A.B. GÖTAVERKEN  
S. STOCKHOLM  
DRAWING ARRANGEMENT  
FOR DEEP TANKS

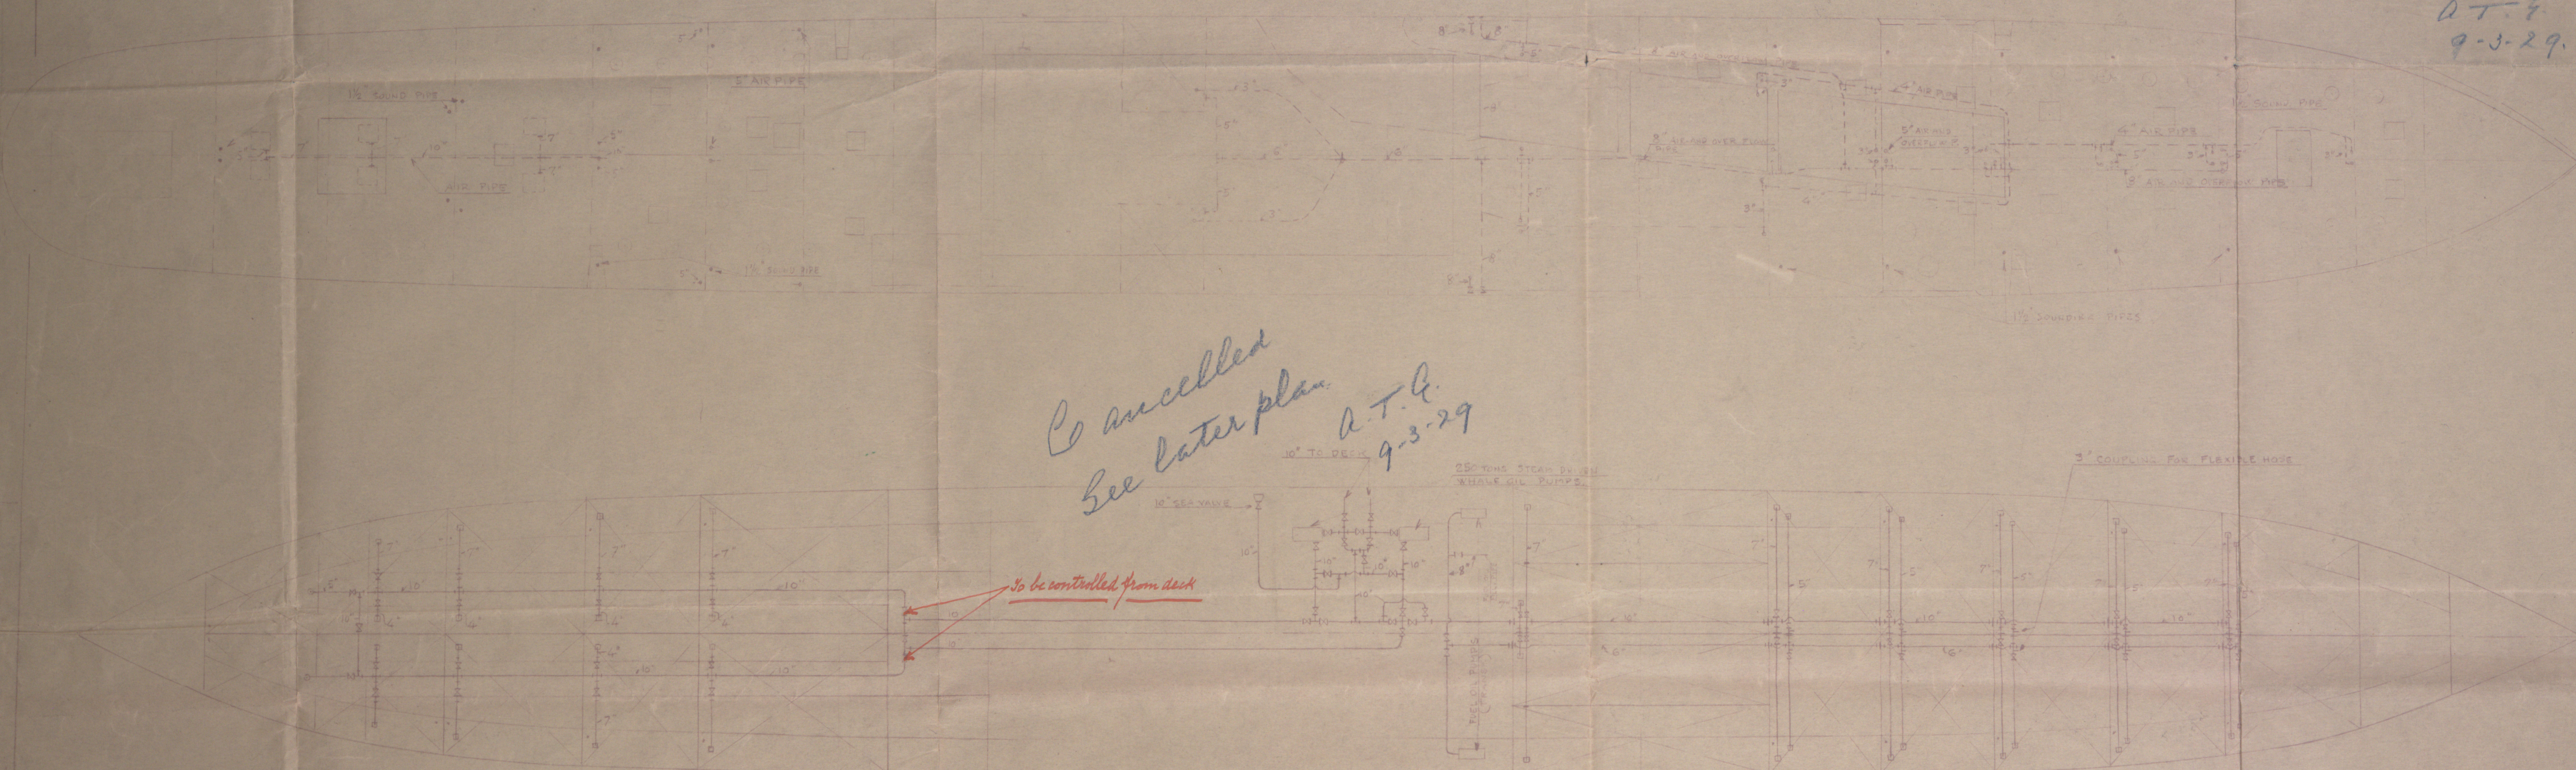
Cancelled  
See later plan  
A.T.G.  
9-3-29.

Cancelled  
See later plan  
A.T.G.  
9-3-29

*to be controlled from deck*

*Doubling plates, or their equivalent, to be fitted under all sounding pipes*

THE FLASH POINT OF THE OIL FUEL TO BE ABOVE 150°F AND THE REMAINING REQUIREMENTS OF SECTION 49 OF THE RULES TO BE COMPLIED WITH.
